PIPELINE SAFETY & RELIABILITY PROJECT (PSRP) (A.15-09-013)

(7th DATA REQUEST FROM TURN)

Date Requested: March 9, 2017 Date Responded: March 23, 2017

Figure 11 at 320 psig failure curve:

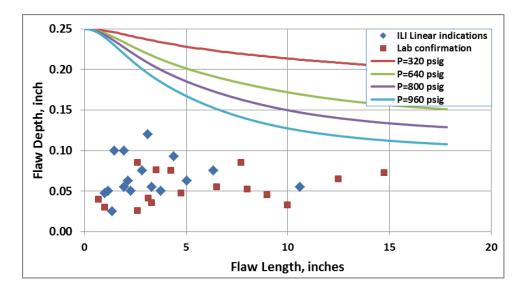
Please provide a copy of Fig. 11, 12 or 13 with a failure curve at 320 psig.

Figures 11, 12 and 13 from Attachment C to SDGE-12 Supplemental Testimony of SDG&E and SoCalGas shown below, have a failure curve at 320 psig added for purposes of this data request response.
